## **SPD1000X Over Current Protection (OCP) function added in Firmware Revision 2.1.1.9**

**March 15, 2022**

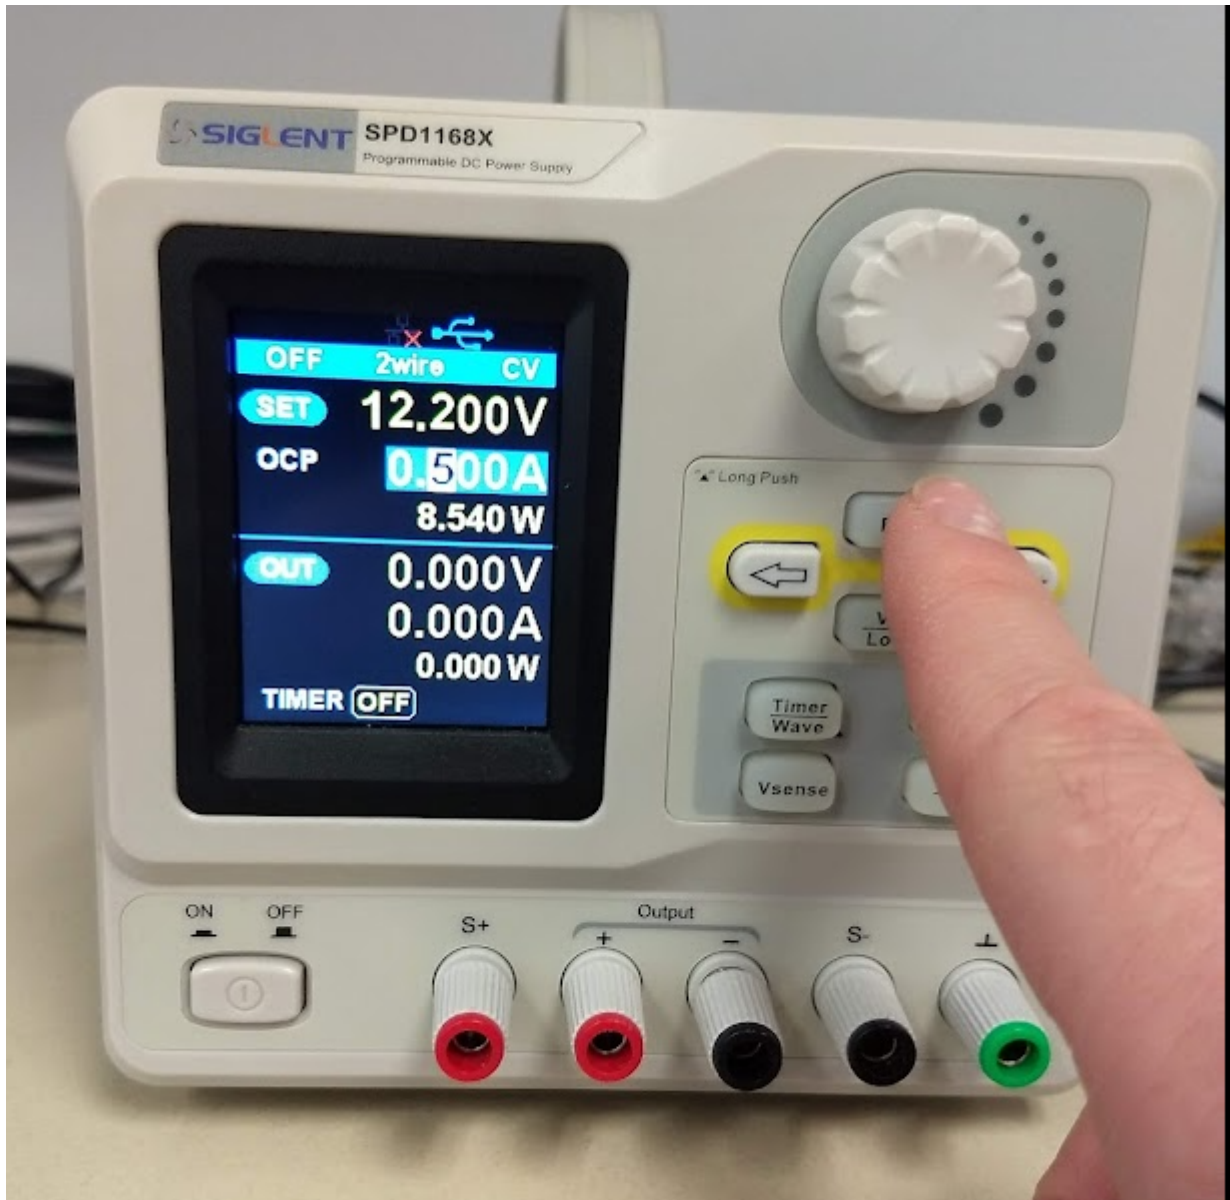
1. Update the [firmware](#)
2. Set the OCP value by pressing and holding the FINE button on the front panel. After a few seconds, the OCP label will appear:

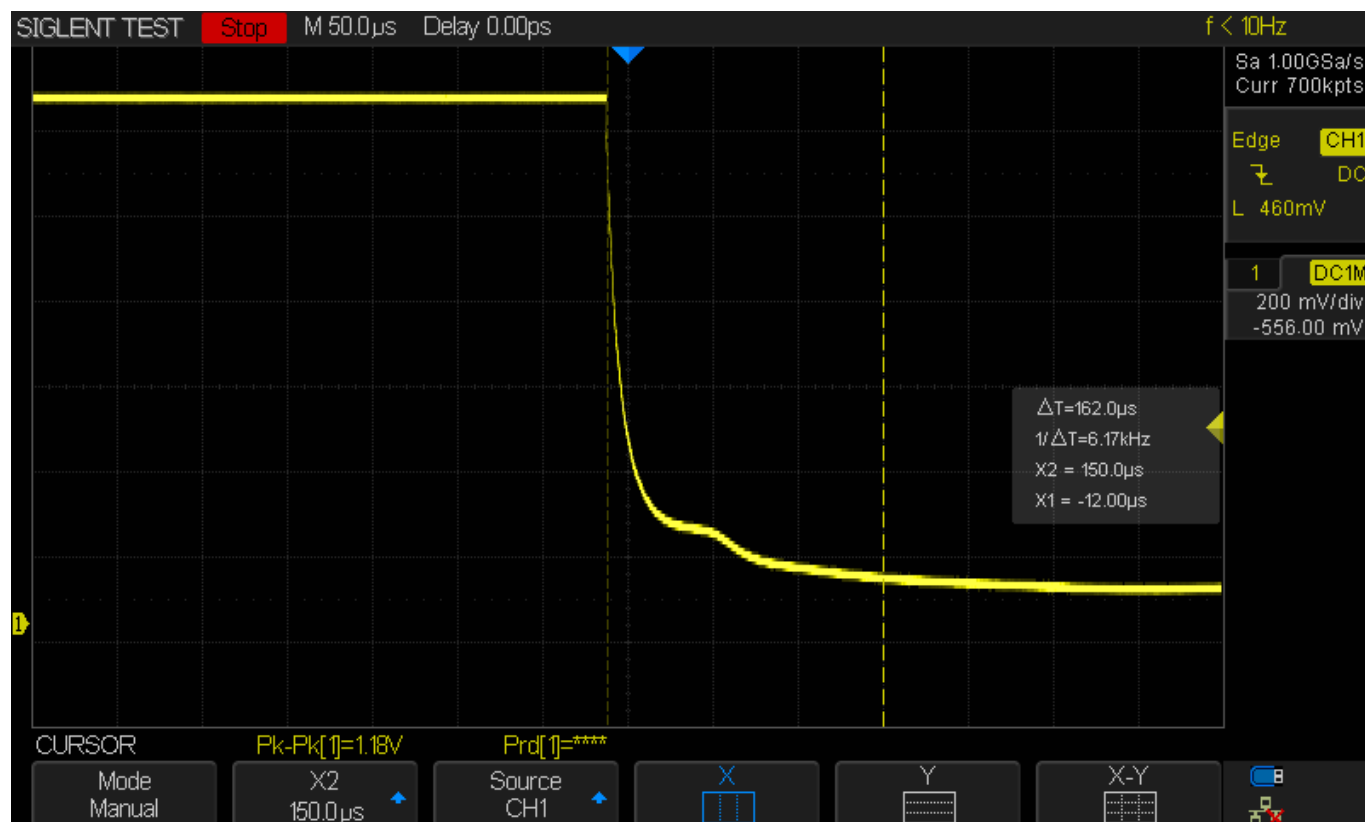
3. Set the OCP current value using the knob and right/left arrows to adjust.
4. Long press the FINE button to remove the OCP menu selection.
5. If the output exceeds the setpoint, the instrument will immediately disable the output and briefly show an error:

Here is an oscilloscope trace showing a shorted output causing an overcurrent situation (OCP triggered):
